Access Compliance Report Public Rights-of-Way (Curb Ramps)

Main Street: SNAPDRAGON_ST Cross Street: BELLFLOWER_ST Location: W

ADA ID: RPAT211101131722 Ramp Type: Type 1 - Perpendicular Diagonal Initial Pass/Fail: Fail Overall Compliance: No Severity Score: 2

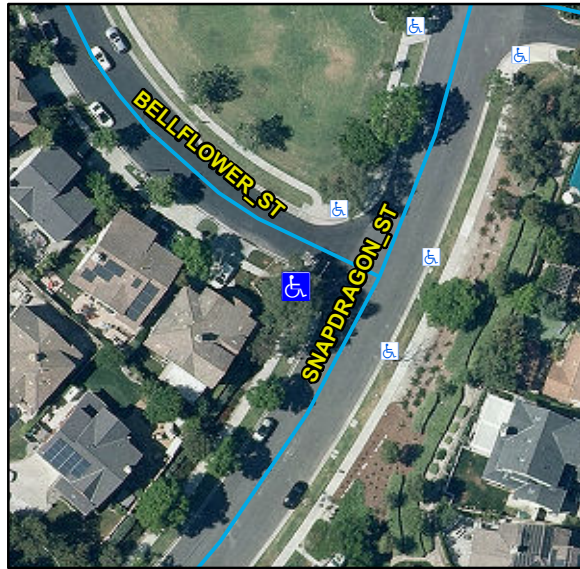
R304.2.2, R204.3, R304.5.3, STD 1115

Remove & Replace Curb Ramp With Two New Directional Ramps or Equivalent.
